ATB51817 REV-1 (1407)

Buzz or Static Heard at Other End During HFL Call

Supersedes 14-029, dated July 03, 2014, to revise the information highlighted in yellow.

REVISED ILLUSTRATION

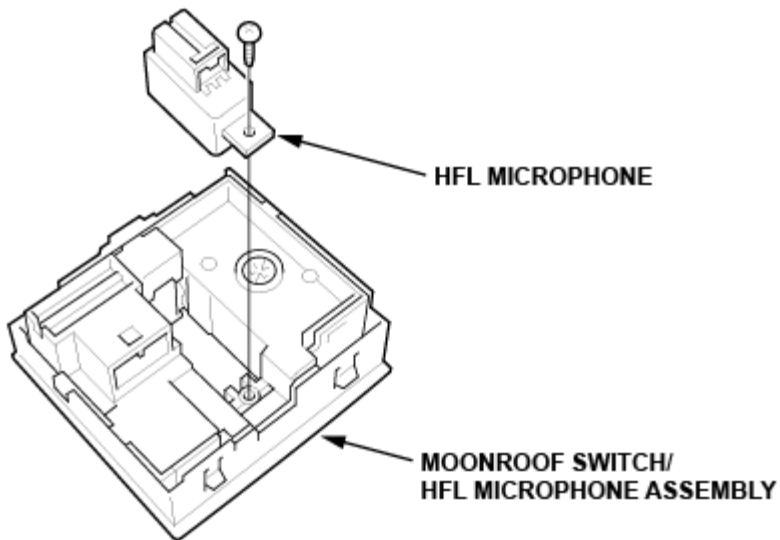
8. Inspect the side of the microphone unit. There will be two lines of numbers. The first two characters of the top line is a date code (circled below).

- Microphones with **date code 3J (2013 October) or after** have the updated design. If the vehicle already contains an updated microphone, do not replace it. Instead, proceed with normal troubleshooting.
- If the microphone has a date code that is before 3J, replace it with a new service part.
